# Service Bulletin

S.B. No: 185

**Title:** INSPECTION FOR AND PREVENTION OF WATER INTO NACA AIR INTAKE

**Applicability:** T67M200 (Post Mod M915), T67M260 and T67M260-T3A (Post Mod M566).

**FIGURE 1**  
**SHOWING POSITION OF AIR INTAKE BOX MOUNTING GRP PREFORMS**

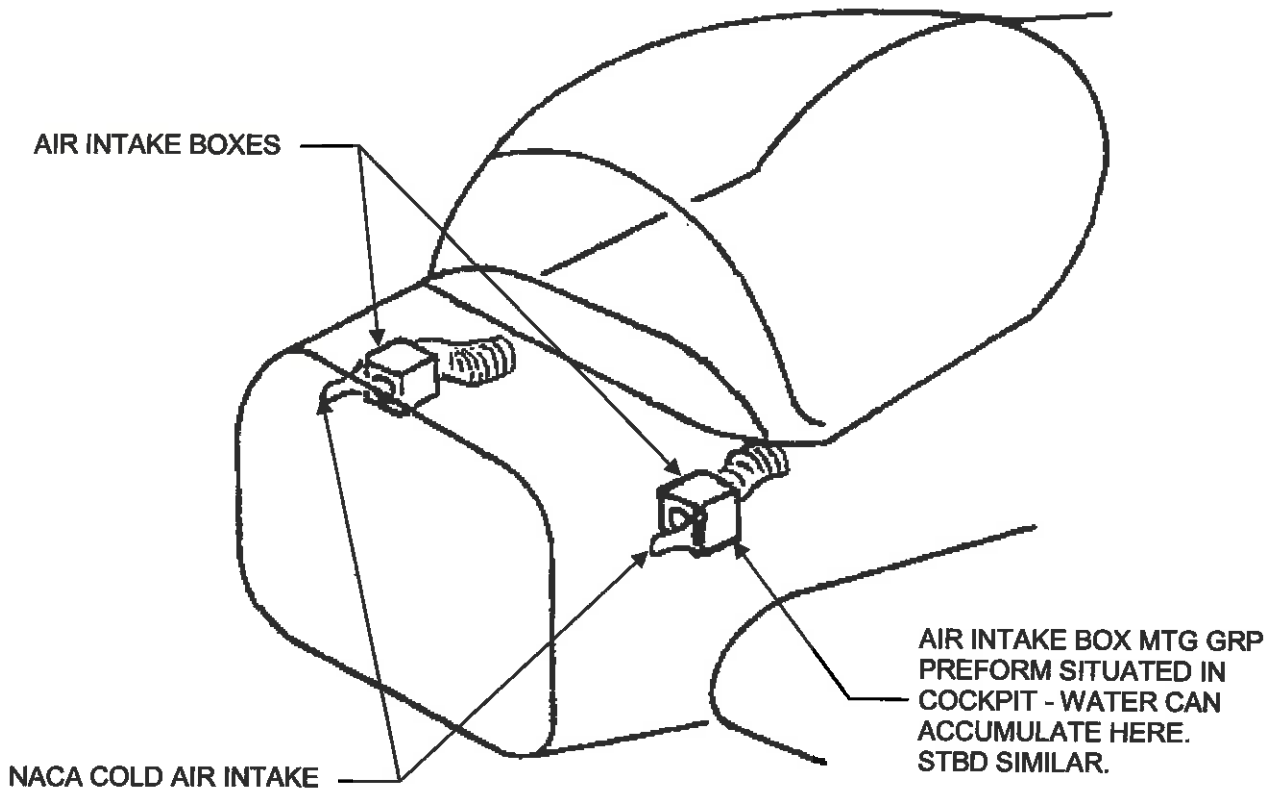
A case has been reported of water accumulating in the cold air intake box GRP mounting preform situated behind the NACA air intakes in the cockpit. When the aircraft was flown the water migrated down the avionics cooling pipe and in this case damaged the Com2/Nav2 box. The aircraft had been parked in torrential rain without covers on.

1. Determine whether there is water in the GRP preform by viewing thru the NACA ducts, or by using a "dipstick".
2. If water is found remove the water, if necessary gain access to preform by removing cold air intake air box, see Figure 1, remove IAW the relevant aircraft's Maintenance Manual. Replace air intake box if removed.

5. Annotate in aircraft logbook SB 185 complied with.
6. SACL do provide a drain for the GRP preform Change Mod M1023 "Introduction of Drain/Drain Hole in NACA Air Intake Box Mounting Preform" applies. For Change Mod Bulletin M1023 and Mod Kit T67A-05-1023, contact Kathy Cooper SACL Product Support Department, or email [kathy.cooper@slingsby.co.uk](mailto:kathy.cooper@slingsby.co.uk).
